**PUERTO RICO HURRICANE MARIA DISASTER RELIEF (DR-4339-PR)
PROJECT #64118 / MPPA012 VIEQUES REGIONAL AIRPORT
ANTONIO RIVERA RODRIGUEZ AIRPORT, VIEQUES, PR**

BID NO. 4-56

ADDENDUM NO. 3

1
AR-103
SECOND LEVEL FLOOR PLAN
SCALE: 3/32" = 1'-0"

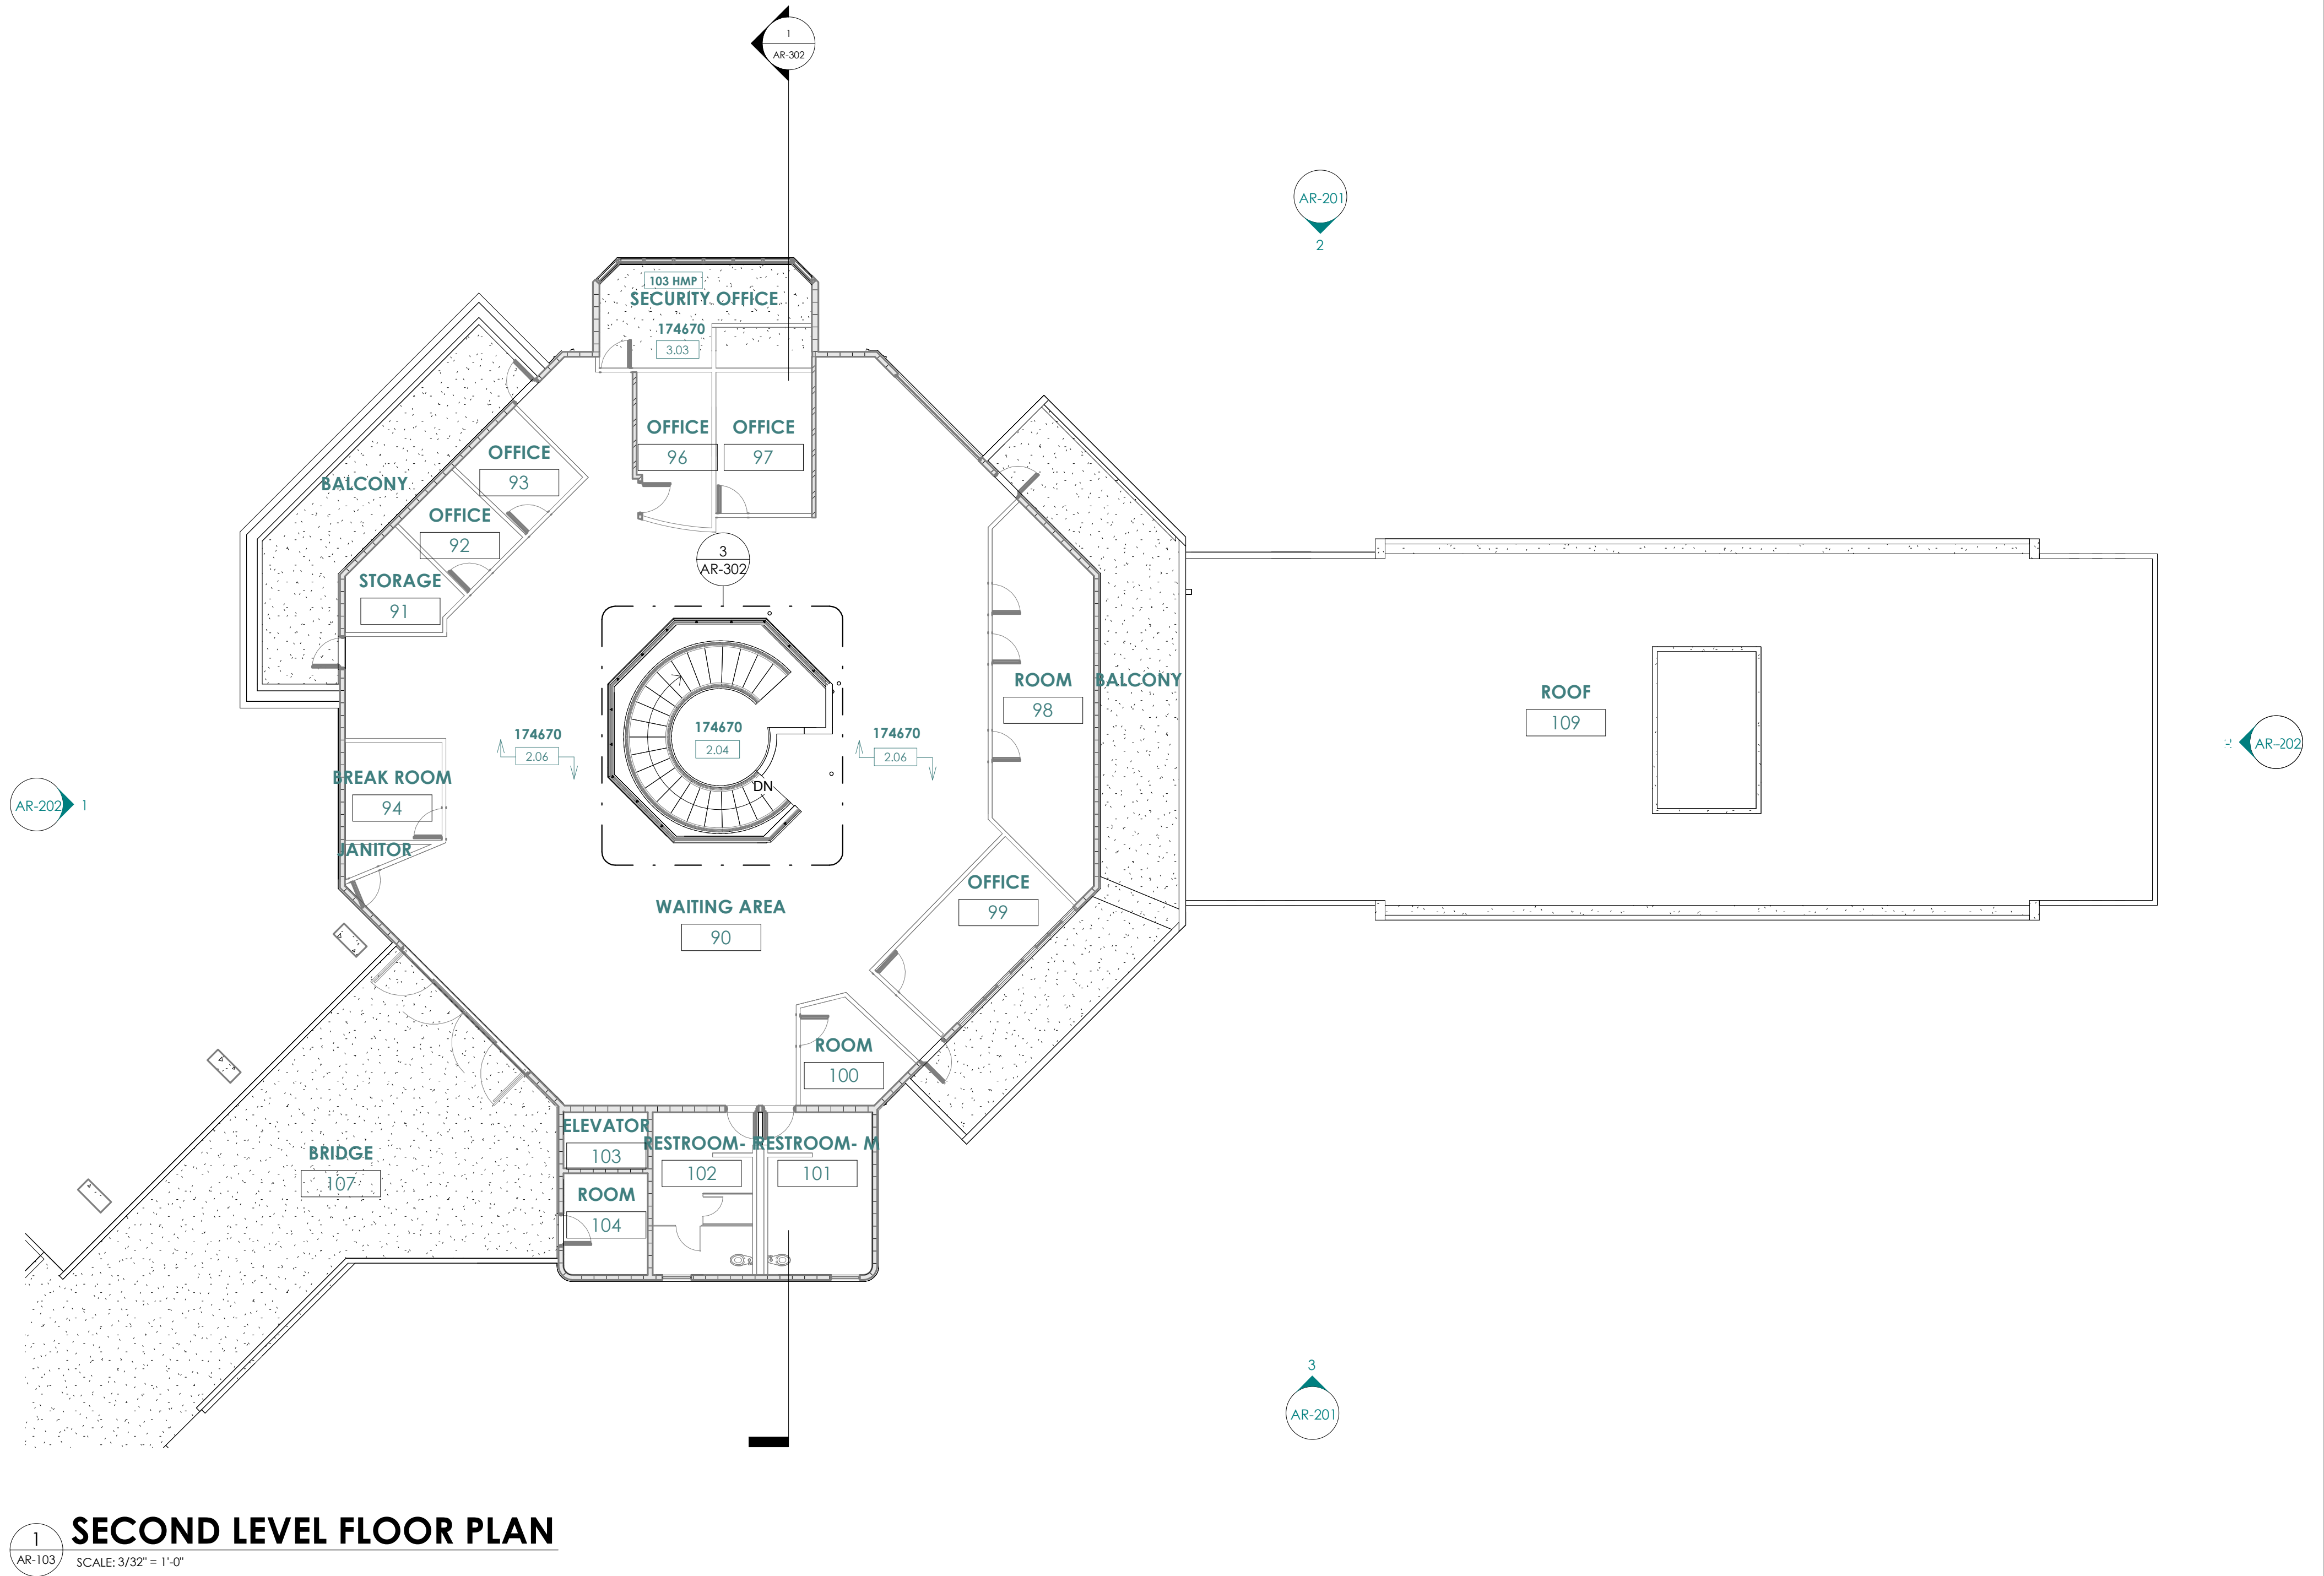
1. The Name of the Project in the Project Manual and the Design Drawings Set shall be construed as the SAME project.
2. The material of the glass guardrail has been changed to STEEL PLATES. Refer to Note 2.04 B in Drawing Sheets AR-102 to AR-106, AR-201 & AR-202, and AR-301 & AR-302.
3. The List of Revised Drawings mentioned above as part of this Addendum is a way to notify Bidders of the Drawings Sheets that have changed from the original Project Manual, Design Drawings Set and other bid documents.

2.04 A - THE GENERAL CONTRACTOR SHALL REMOVE AND REPLACE ONLY THE TWO (2) DETERIORATED AND/OR BROKEN GLASS RAILING PANELS (262.50 SF APPROX.) AT THE SECOND-FLOOR GUARDRAIL AREA. NEW GLASS PANELS SHALL MATCH THE EXISTING SYSTEM IN MATERIAL, DIMENSIONS, THICKNESS, FINISH, AND APPEARANCE, INCLUDING ALL REQUIRED FITTINGS AND ACCESSORIES FOR A COMPLETE AND CODE-COMPLIANT INSTALLATION.
